PIC16F62X Rev. A Silicon/Data Sheet Errata

The PIC16F62X (Rev. A) parts you have received conform functionally to the Device Data Sheet (DS40300C), except for the anomalies described below.

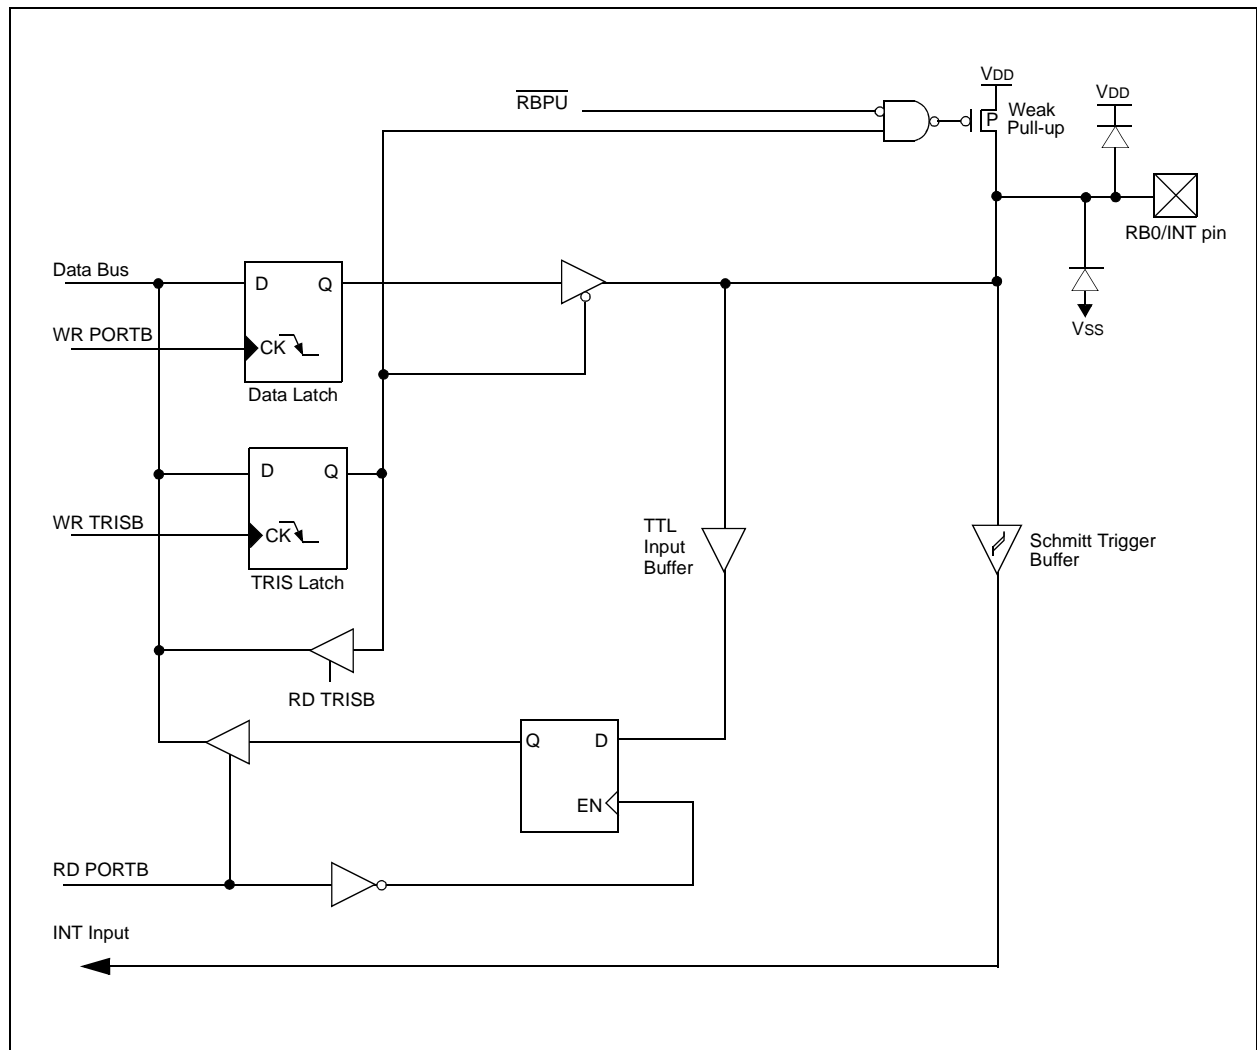
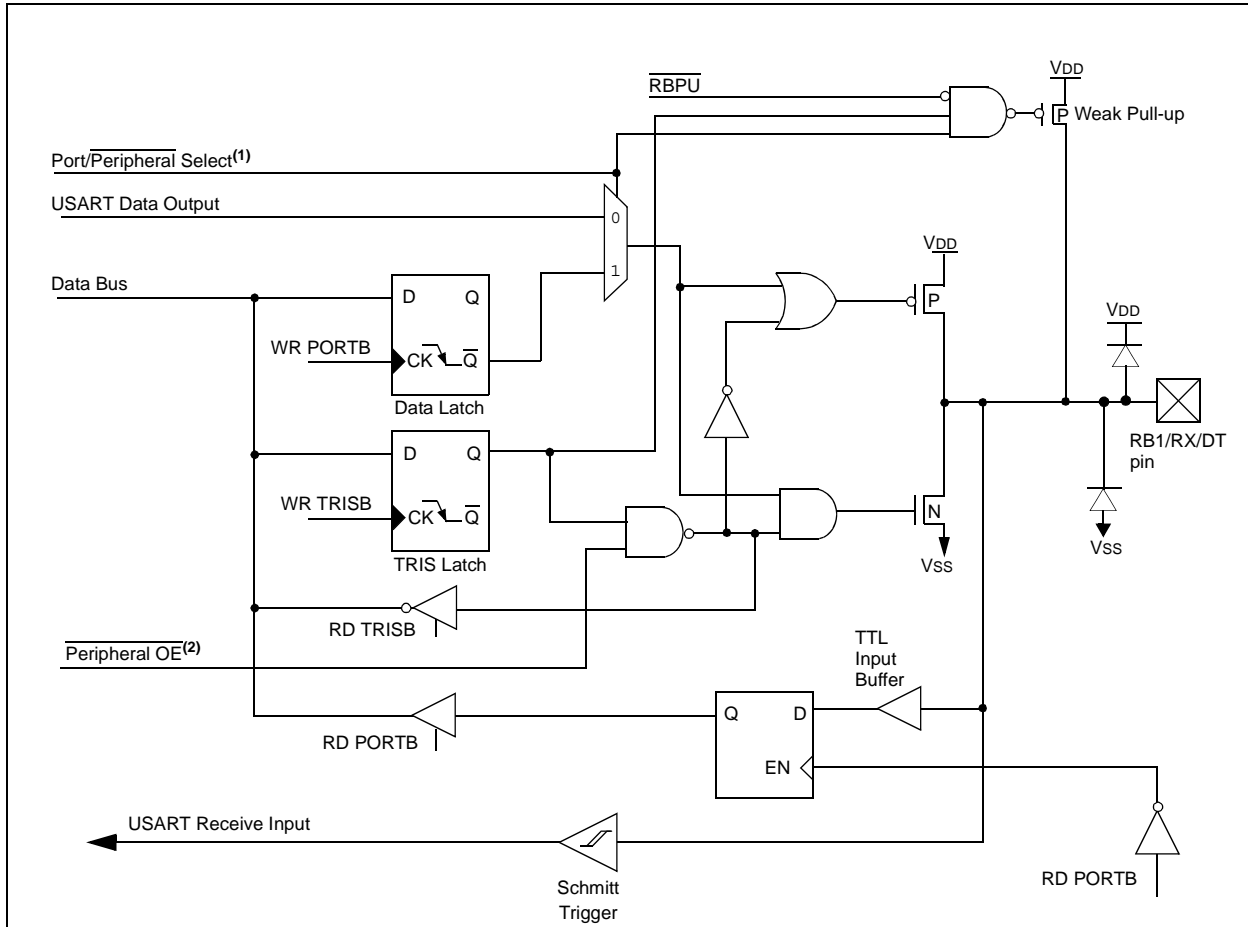
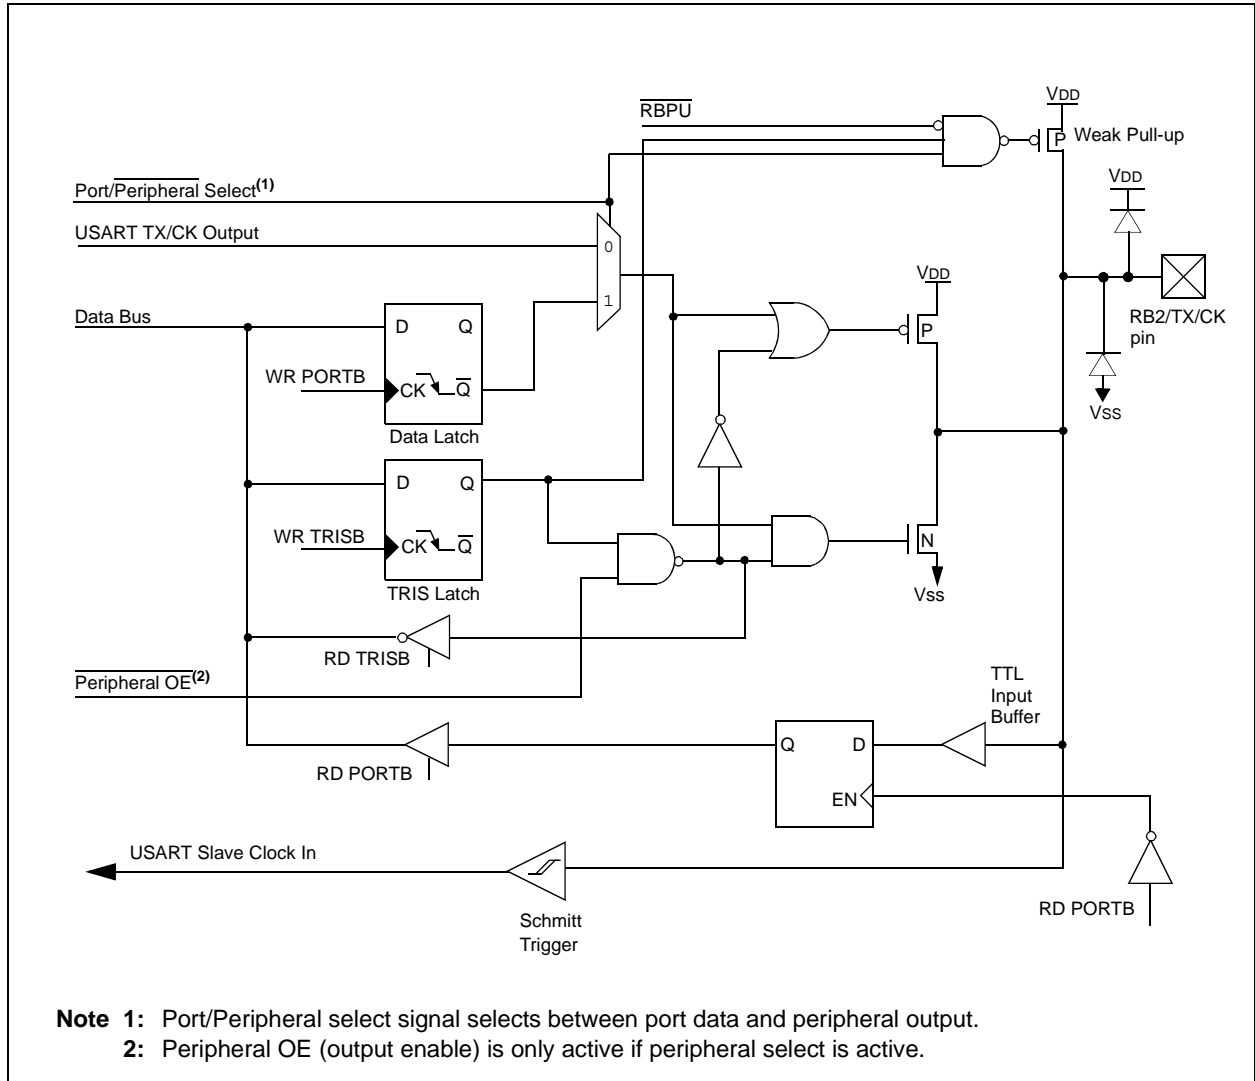
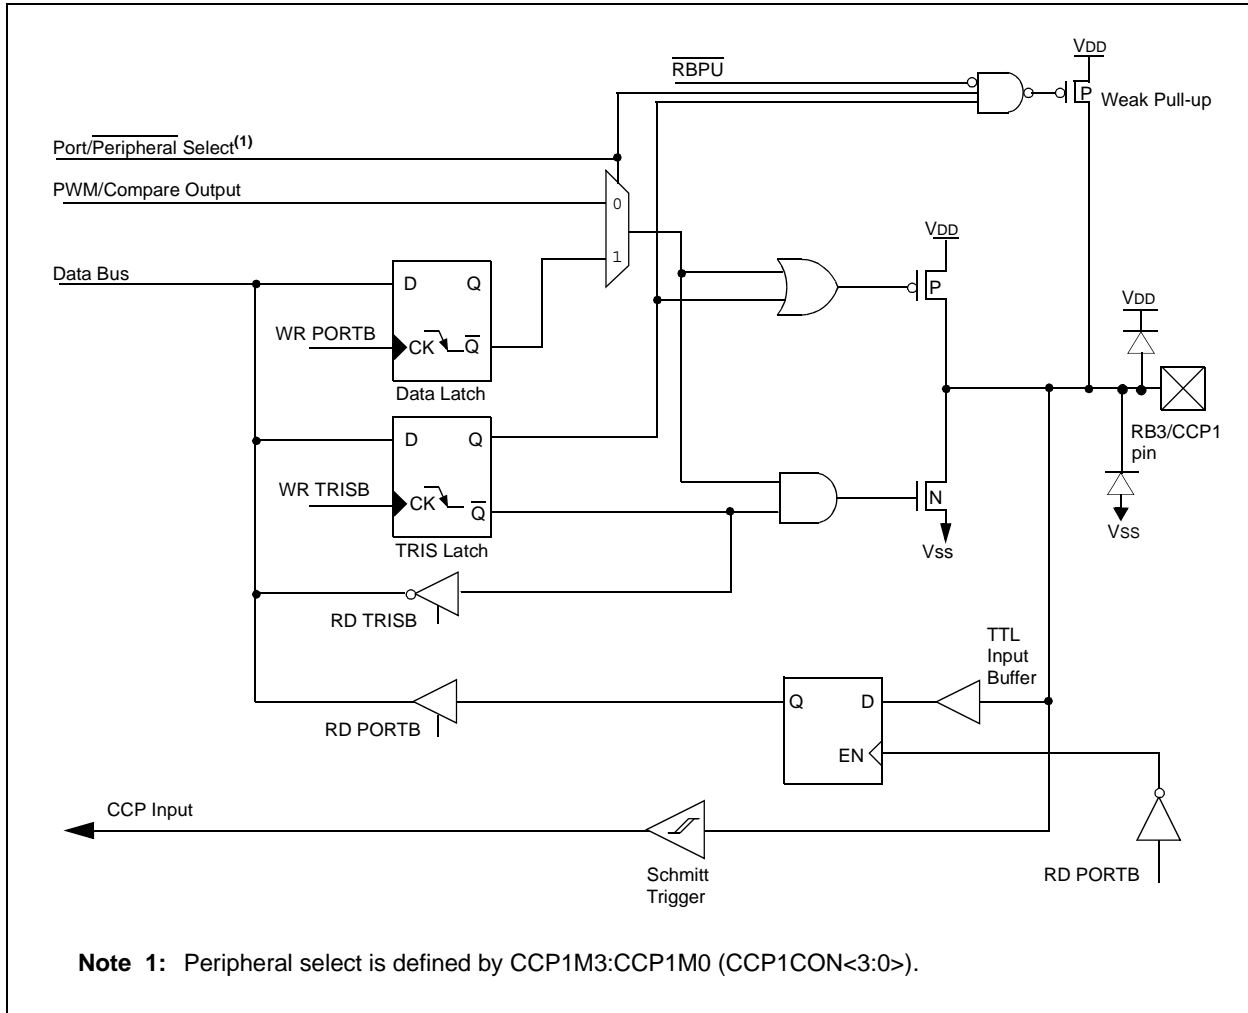
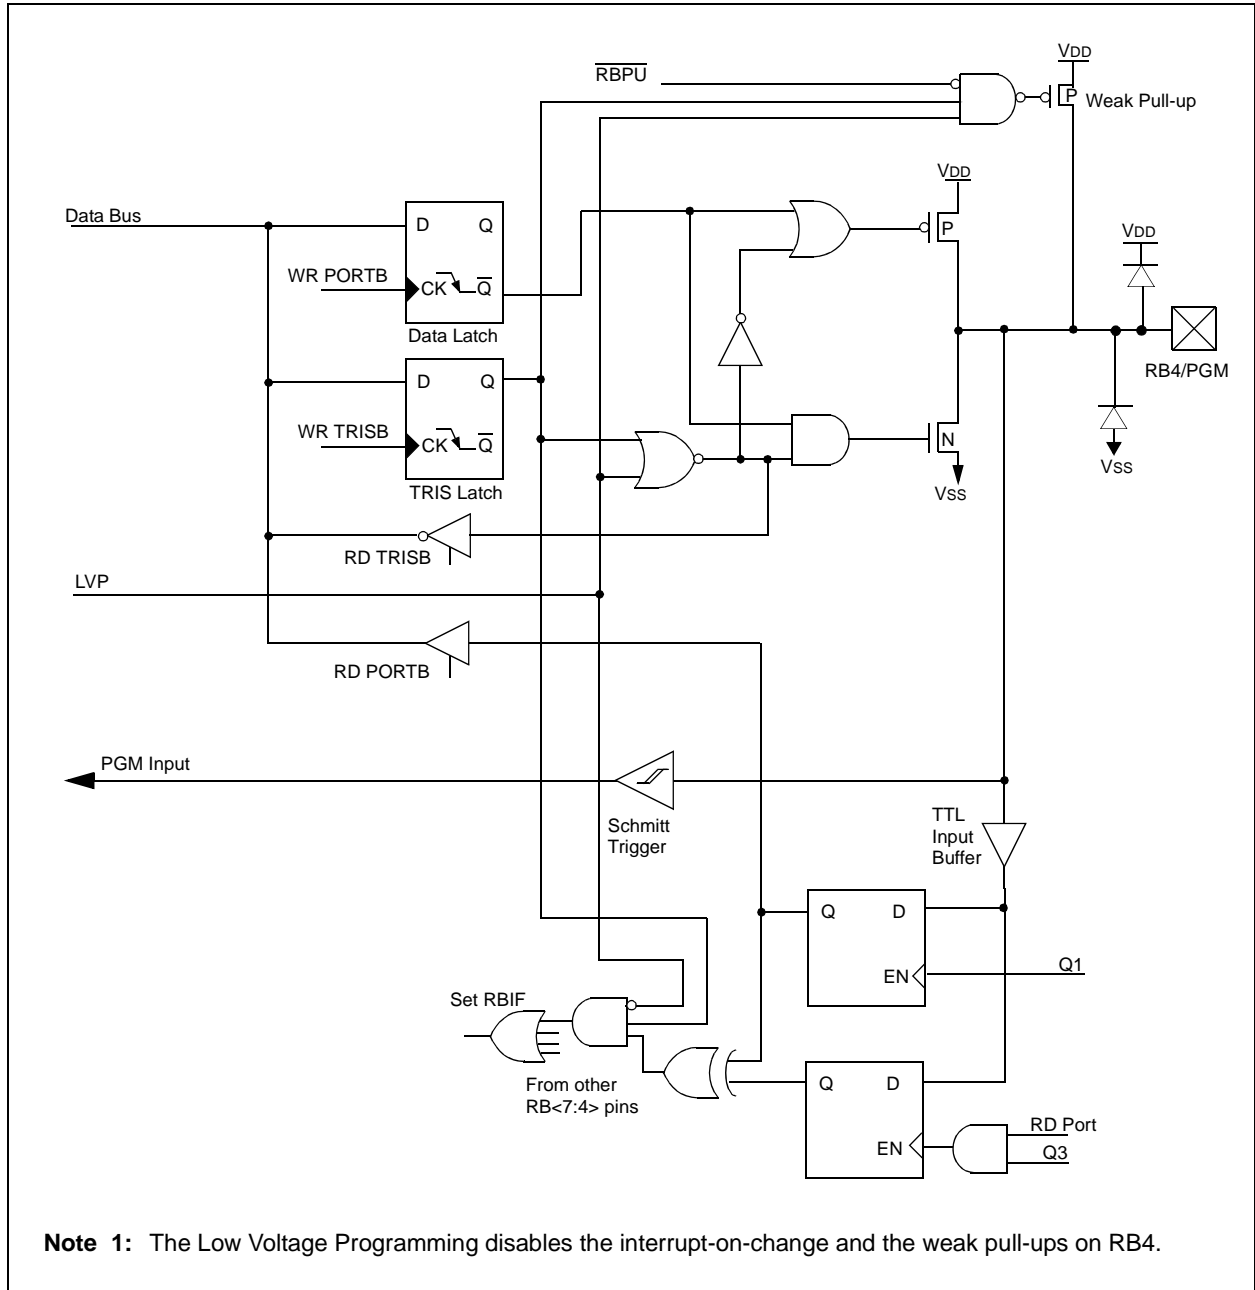
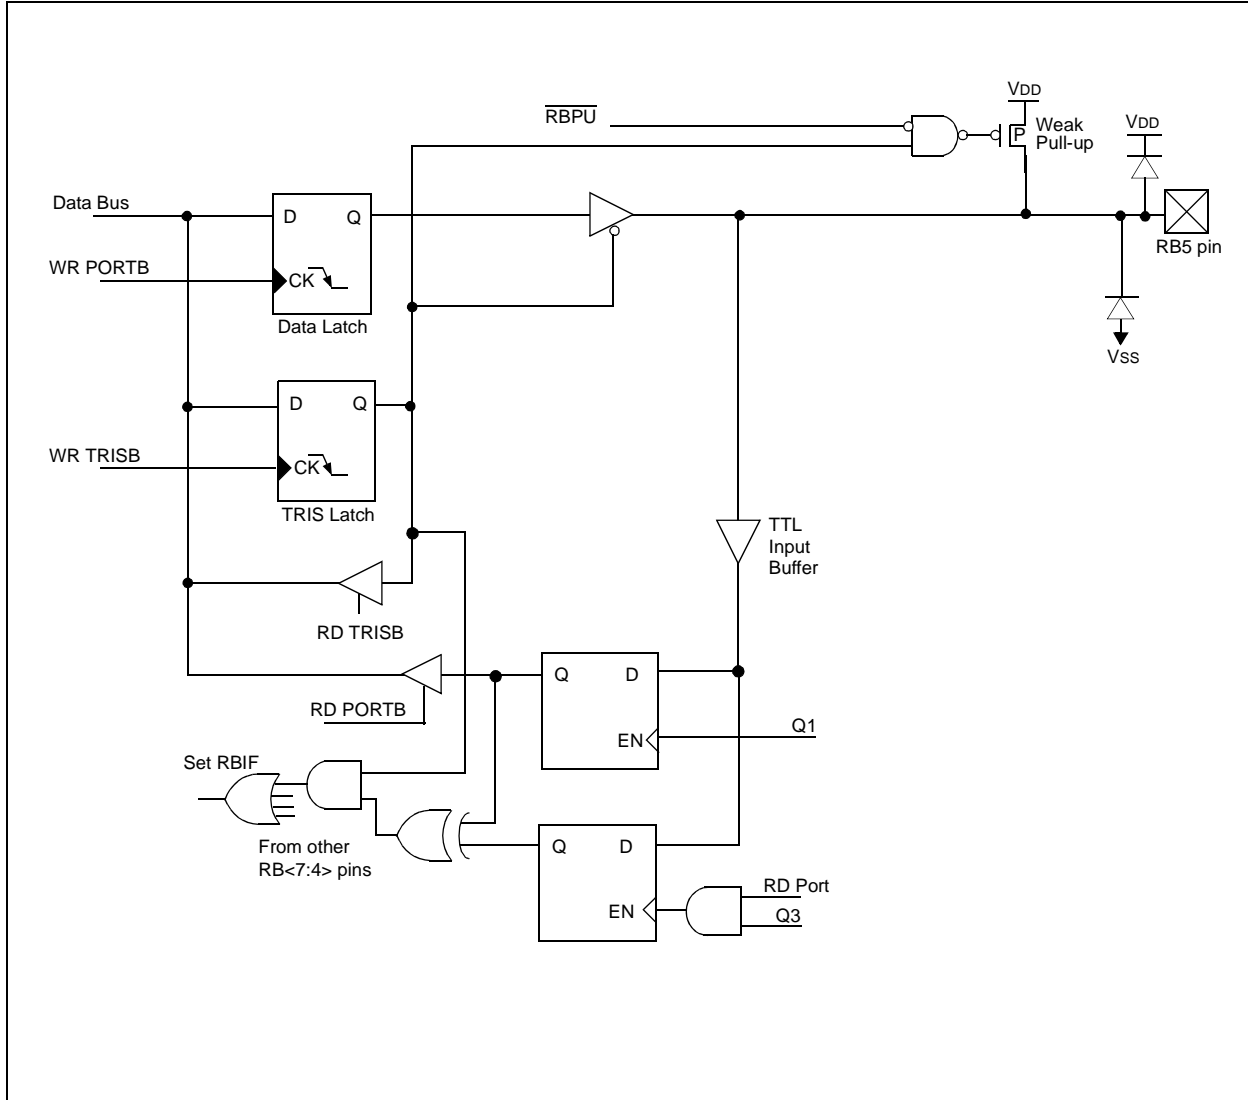
1. Module: I/O Ports

A read of the PORTB Data Direction Register (TRISB) returns the Data Direction state on the port pins themselves and not the contents of the TRISB register latch.
